METROPOLITAN GOVERNMENT OF NASHVILLE AND DAVIDSON COUNTY

STAFF RECOMMENDATION
2007 Sweetbriar Avenue
September 19, 2012

Application: Demolition—accessory structure; New construction—accessory structure;
Setback reduction

District: Belmont-Hillsboro Neighborhood Conservation Zoning Overlay

A1.3

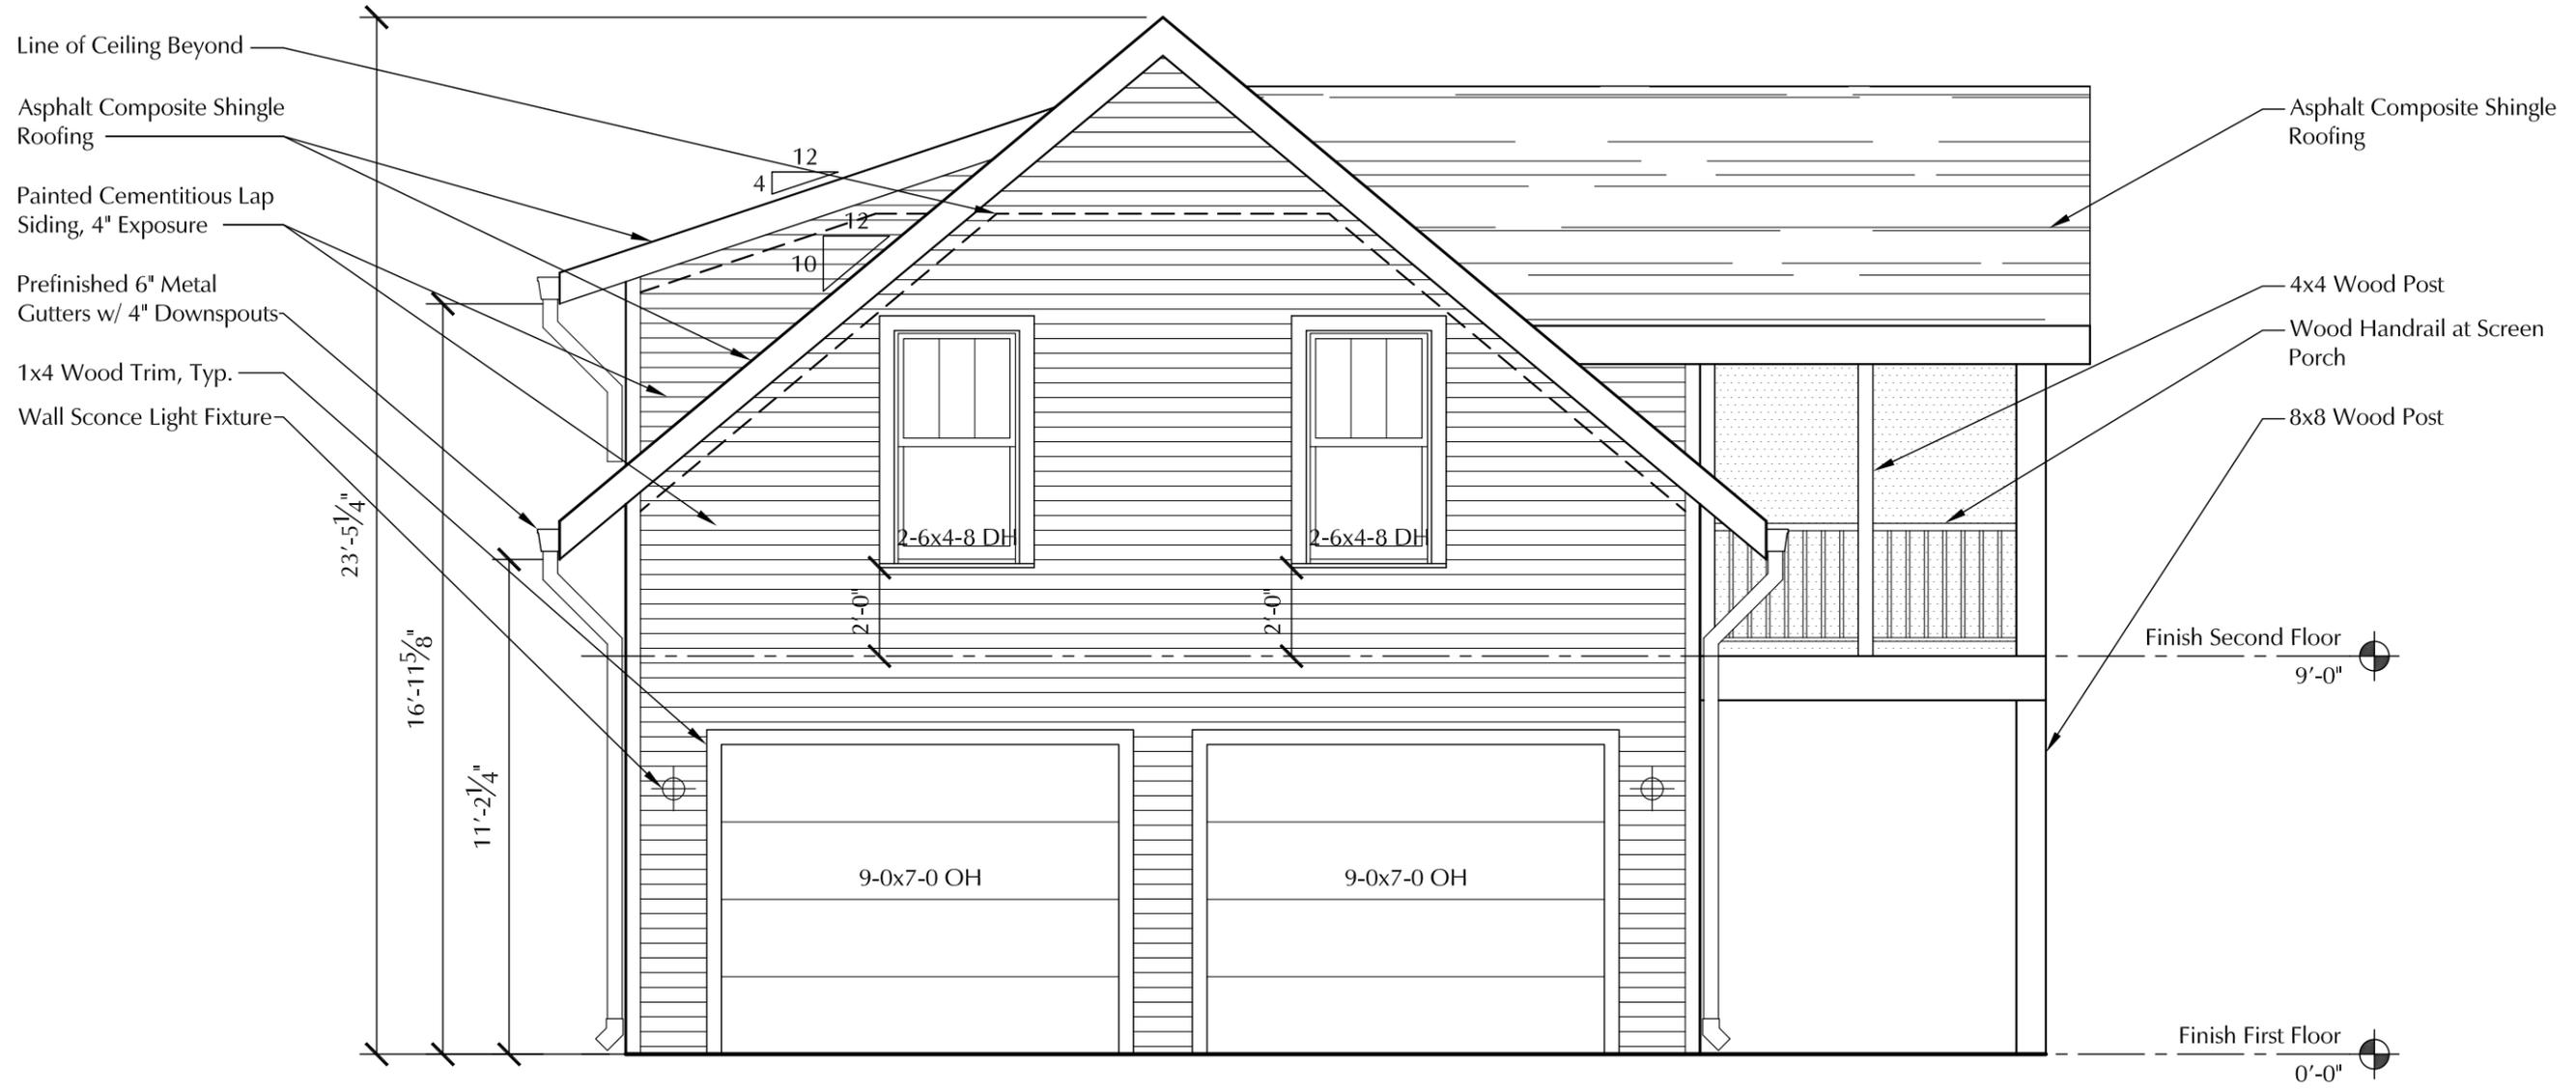
Roof: The accessory structure's primary roof form will be a side gable with a slope of 10/12. The side porch will also have a gabled roof with a 10/12 slope. The east elevation will have a shed dormer with a slope of 4/12, and the west elevation will have two gabled dormers with slopes of 10/12. Staff finds that the roof forms are appropriate for an accessory structure and meet Sections II.B.1.e. and II.B.1.i. of the *Belmont-Hillsboro Neighborhood Conservation Zoning Overlay Handbook and Design Guidelines*.
